## COUNCIL ASSESSMENT REPORT

### SYDNEY EASTERN CITY PLANNING PANEL

| <b>PANEL REFERENCE &amp; DA NUMBER</b> | PPSSEC-282 – DA/2023/0467   |
| <b>ADDRESS</b>                         | Lot 2 in DP 1015843 - 469-483 Balmain Road LILYFIELD  |

Figure 12: Existing tree plan (trees for removal identified in red)

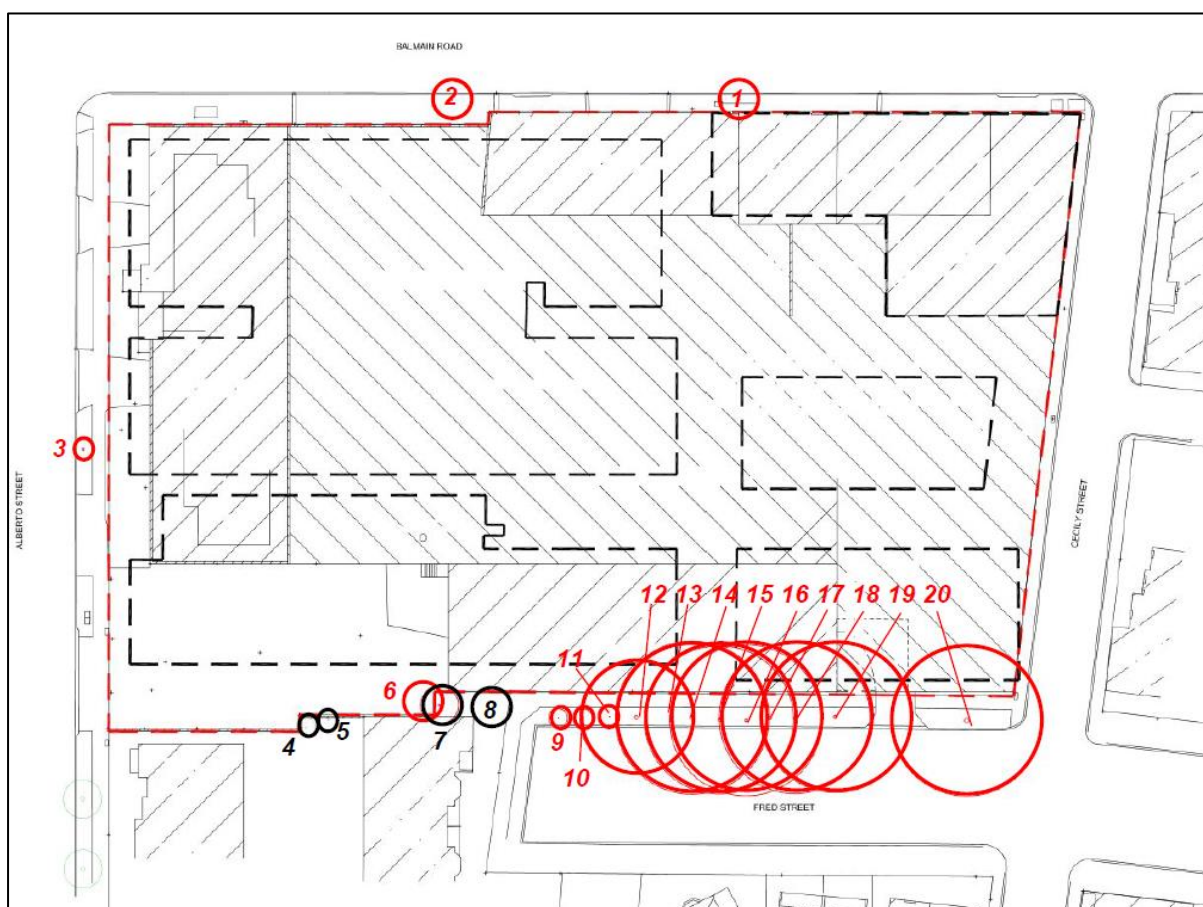
The existing street trees on Fred Street are London Plane Trees and have been subject to severe pruning due to the location of above ground powerlines. Their removal will allow for the powerlines to be relocated underground and for a more suitable species (Yellow Bloodwood) to grow uninhibited in accordance with the Tree Strategy Plan (figure 14). As such the proposed removal of the street trees is supported subject to supplementary planting.

Overall, the proposal is considered acceptable with regard to the SEPP and DCP subject to the imposition of conditions protecting the surrounding trees, and compensatory plantings to be planted under the supervision of a Project Arborist.

*Figure 14: Tree planting strategy plan*

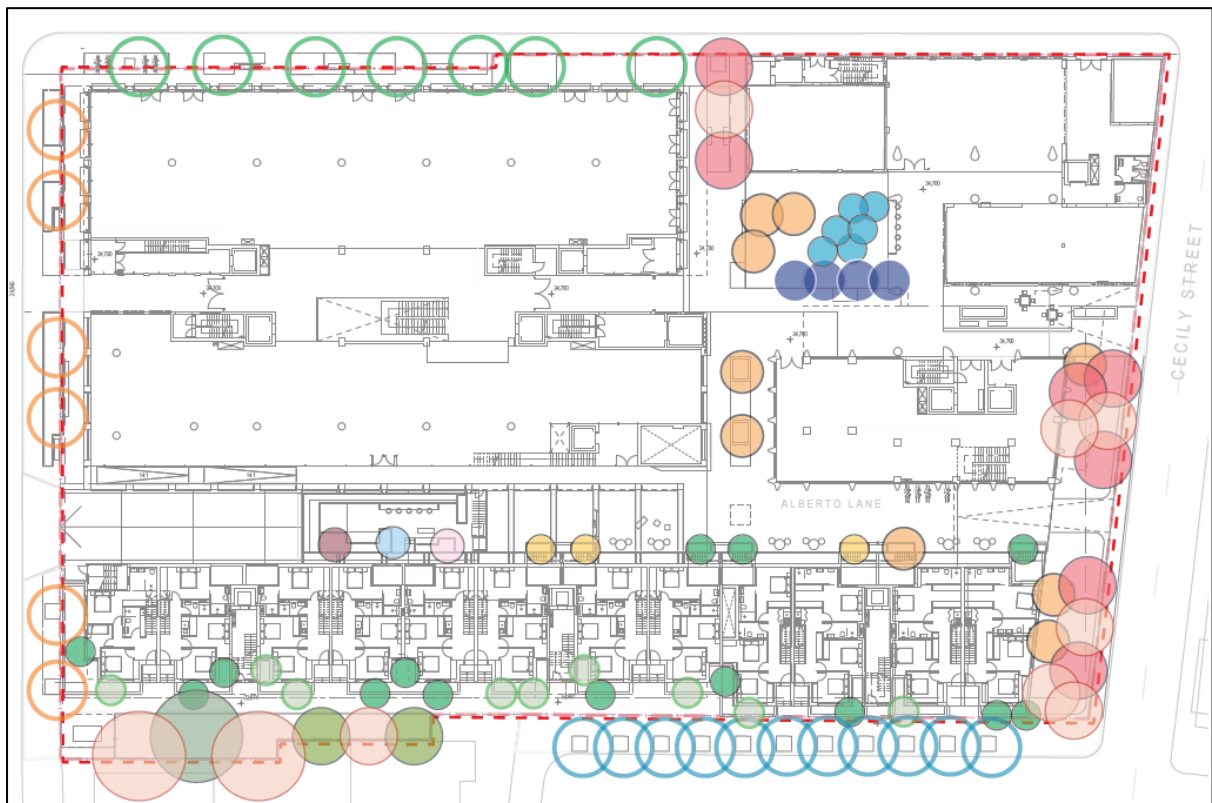
In relation to the retained trees, a condition is included in the recommendation requiring that tree protection measures are implemented in accordance with the Tree Protection Plan.

Figure 15: Balcony separation on podium level

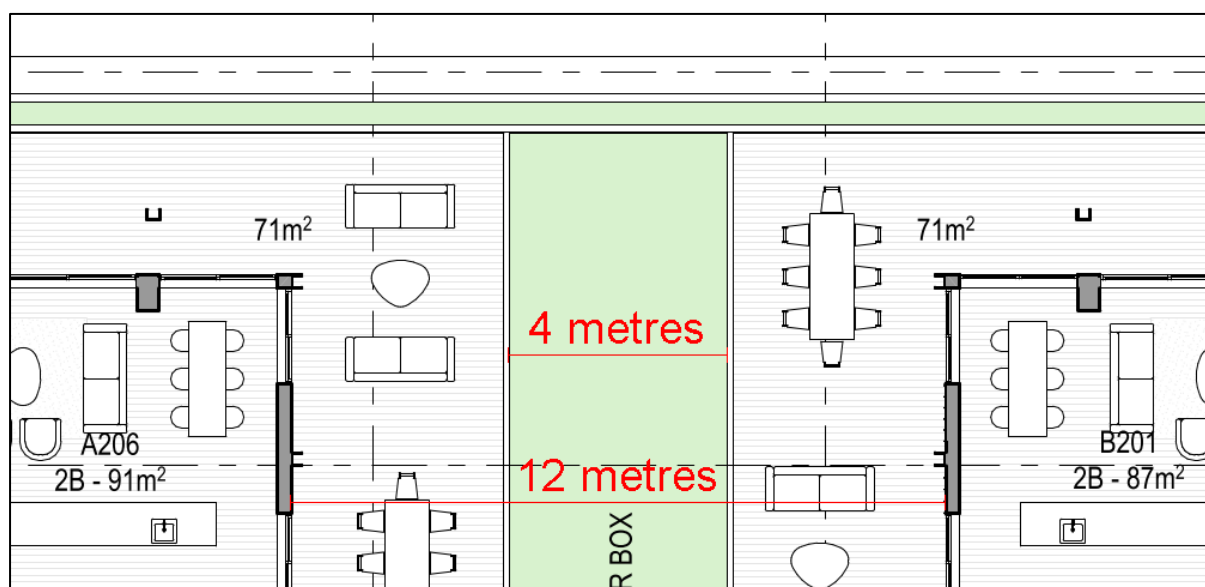
As illustrated in figure 15, A206 and B201 provide a non-compliant balcony to balcony separation of 4m. The setback is considered acceptable in this instance as the amenity provided from the oversized 71sqm balconies which have dual aspects to the west and north, and are considered an overall better outcome for the apartments. The balconies are separated by a raised planter box with substantial vegetation including trees which affords a supplementary source of privacy. It is considered that visual and acoustic privacy can be reasonably managed by the occupants without additional mitigation measures.

A further non-compliant balcony separation is located on the podium level between A205 and B202 with a separation distance of 5.2m. B202 includes a privacy screen to a height of 1.6m which resolve visual privacy impacts, and as such the setback is considered acceptable in this instance.

*Figure 16: Pinch point buildings A and B*

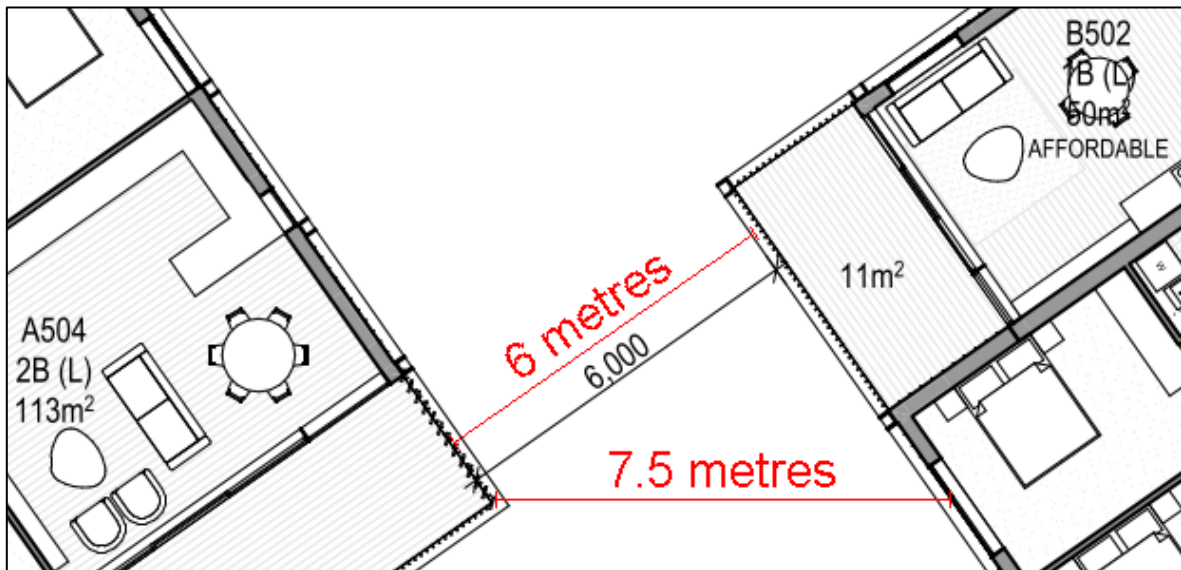
As illustrated in figure 16, A504 and B502 and B503 provide a non-compliant balcony to balcony/habitable room separation of 6m and 7.5m respectively. The angular building form results in a 'pinch point' between the two buildings, however on balance this building form is considered a suitable response to reduce the perceived density and was supported by the AEDRP. The 'pinch point' has been mitigated on levels 2-4 by reconfigured apartment layouts with fixed glazing to manage acoustic impacts and as such the setback is considered acceptable in this instance. Level 5 apartment 504 (figure 16), provides a full height louvre to minimise direct overlooking into unit B502.

*Figure 17: Alberto Lane Level 2*

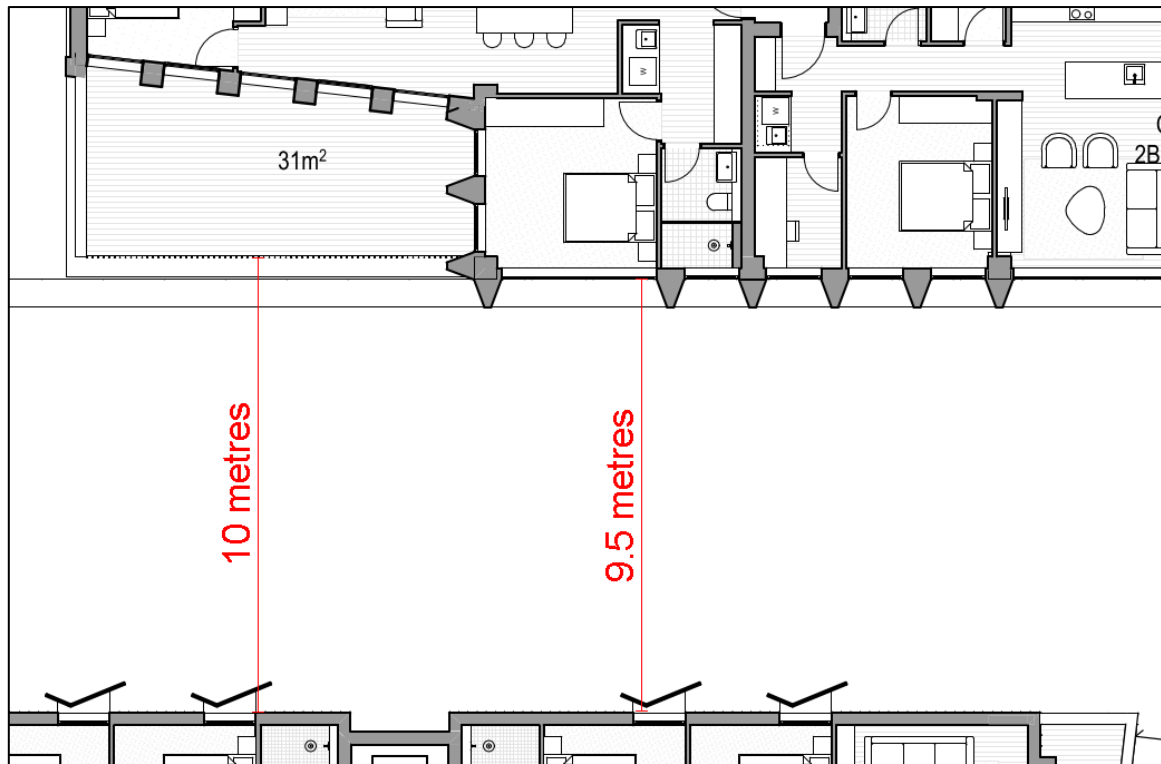
As illustrated in figure 17, building F (apartments F201 and F202) and building C (apartments C202 and C203) have non-compliant habitable room/balcony to habitable room/balcony setbacks of 10m and 9.5m respectively. The setback is considered acceptable in this instance as building F has employed privacy screens to prevent direct overlooking and building C glazing is fixed to mitigate acoustic impacts, with the exception of the balcony. Further, the balcony is located on a corner allowing sound to disperse. Given the future ground floor uses and site zoning, this outcome is considered reasonable.

Figure 18: except of apartment D004

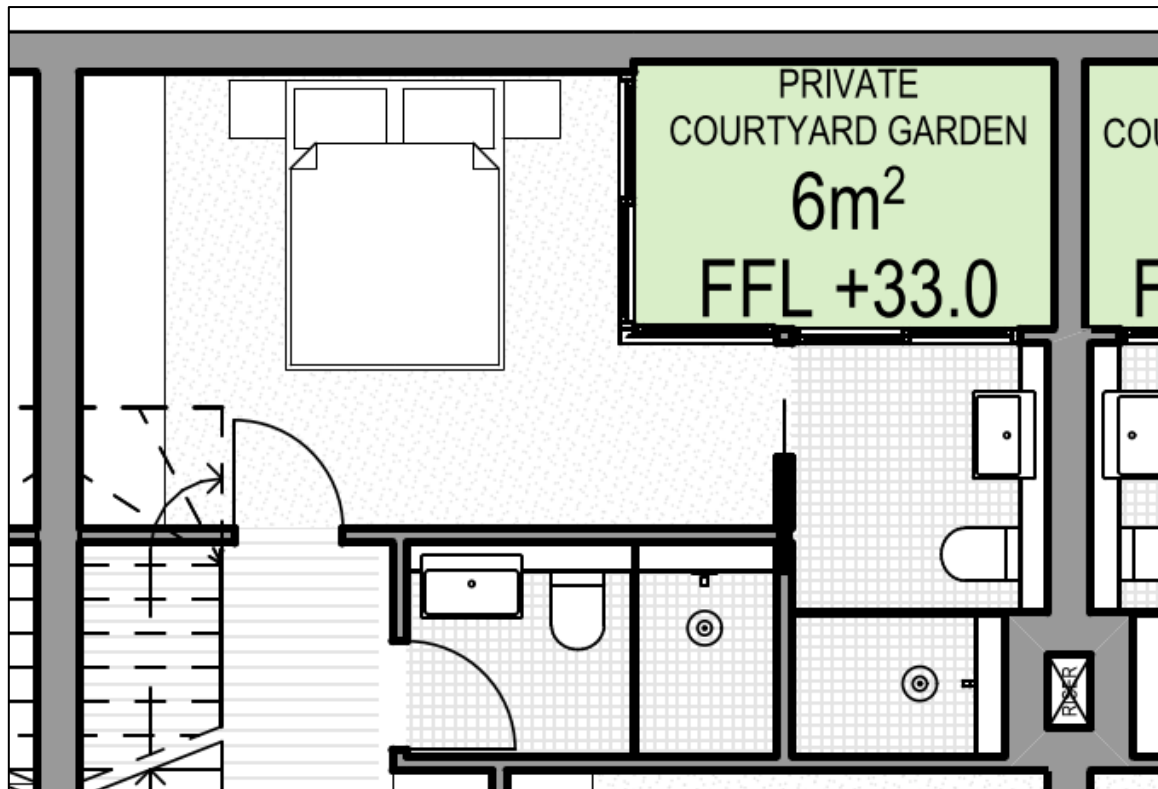
The proposal provides 10 bedrooms (on the ground floor in building D,E,F) which rely on sunken lightwells under double height voids as the only source of light and ventilation to a bedroom (figure 18).

Notwithstanding, the development is considered acceptable with respect to the objectives of this Part of the ADG as follows:

Figure 20: Height plane diagram.

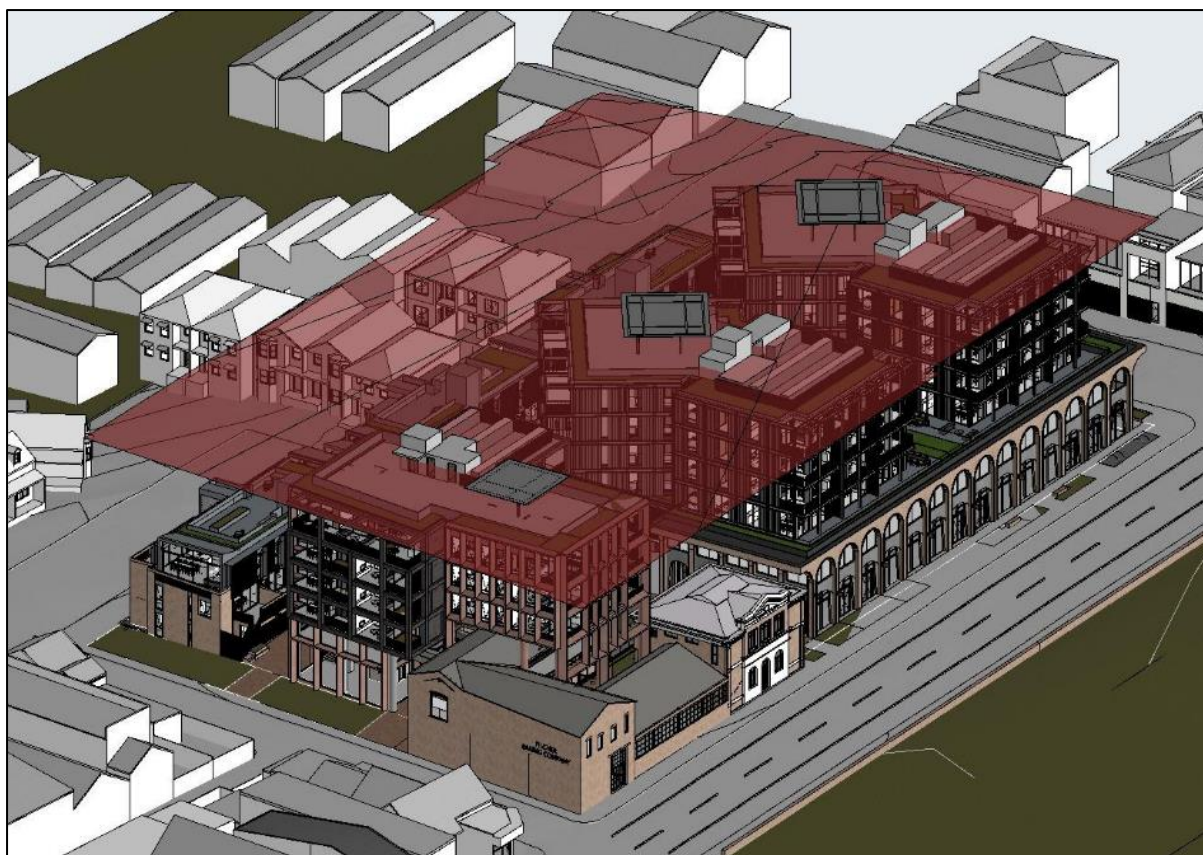
The applicant seeks a variation to the Height of Building development standard under Section 4.3 of LEP by 2.53mm or 11%. The extent of the building elements and proposed variation is illustrated in Figure 20 and outlined in **Table 6** below.

The applicant's written rationale adequately demonstrates compliance with the development standard is unreasonable and unnecessary in the circumstances of the case, and that there are sufficient environmental planning grounds to justify contravening the development standard.
